INSTRUCTION TO SERVICE

ITS: 5850	
SECTION:	350 Drivers Controls
WRITTEN BY:	Ken Chubaty
SUBJECT:	Replace old stock Smartrend Foot Switches with new stock (improved) Smartrend Foot Switches

Figure 1: Turn Signal Foot Switches

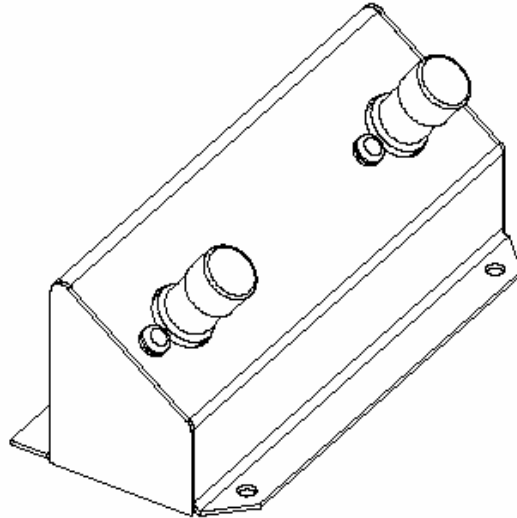
3. To access, remove, and inspect the foot switches; the entire assembly must be pulled up from the floor to gain access to the bottom side of the switch.

4. Disconnect the wiring from each switch.
5. Remove the screws from the top of the assembly to allow the switches to slip out from the bottom.
6. Inspect each switch for a Smartrend stamp on the side.

7. If the switch has the stamp, it is the latest iteration of the switch and should be used. If it does not have any stamps, the switch can be discarded.
8. Using the new switch (PN 5925959) which does have the Smarttrend stamp on the side, install it in place of the old switch. The same hardware can be used.
9. Re-wire the switches with the existing wiring. See Figure 3 for reference.
